**Re: Responsive Comment Supporting Appellant Upper Chinatown
Neighborhood Association and Clayton Timbrell's Appeal of
the Planning Commission's Approval of a Categorical Exemption for the
1151 Washington Street Project (2022-010833ENV; 2022-010833CUA)**

Board of Supervisors Hearing Date: June 27, 2023

Subject: Response to Comments on the 1151 Washington Street Project

EXHIBIT A

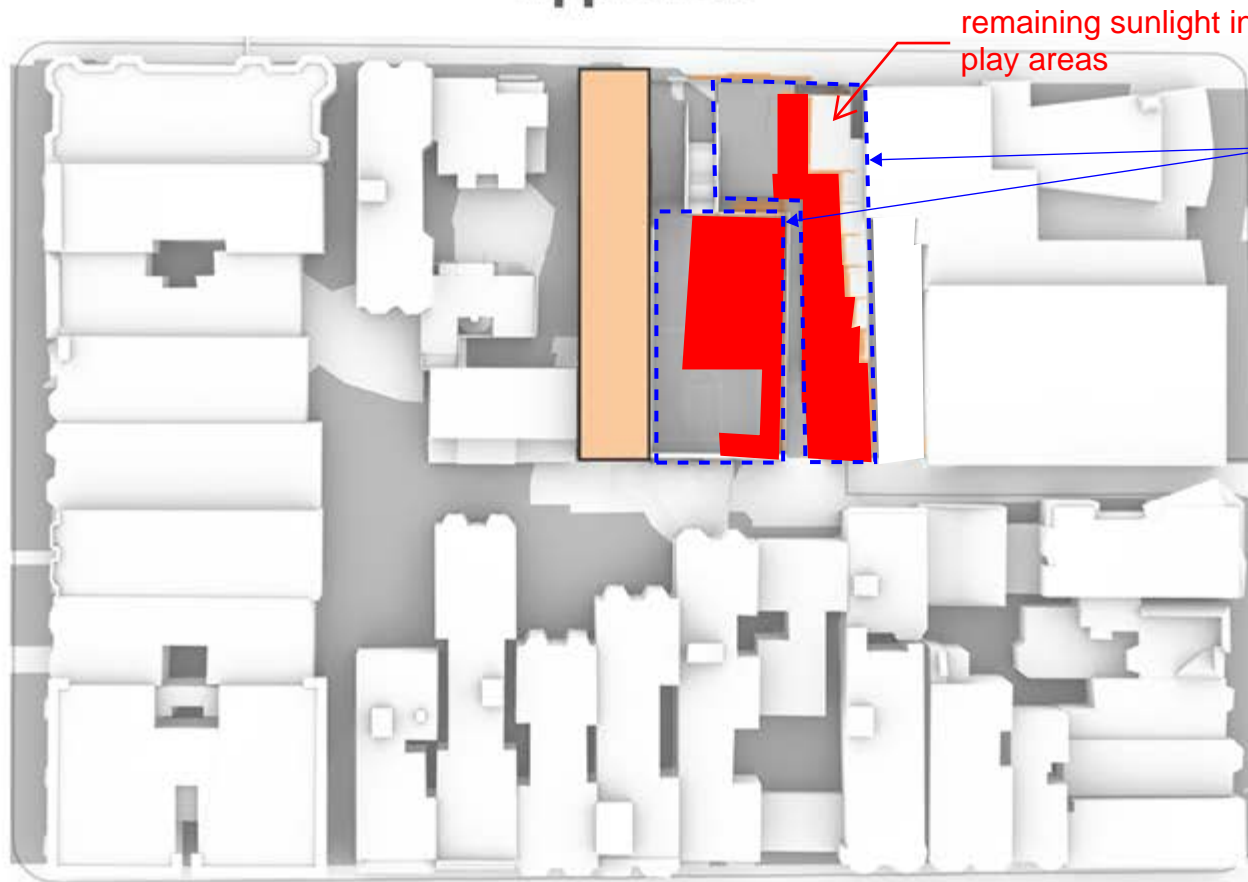
Both the Developer and City argue that Appellants submitted an inaccurate shadow analysis based on a prior version of the Project. This is because the prior version was the operative version at the time the shadow analysis was conducted. However, attached to our June 16, 2023 letter was an updated shadow analysis based on the most recent version of the Project. The updated shadow analysis clearly shows that the Project will have massive shadow impacts on the Betty Ann Ong Recreation Center, causing shadows on **86.2 percent** of the outdoor areas and leaving only a small sliver of sunlight. (Exhibit A).
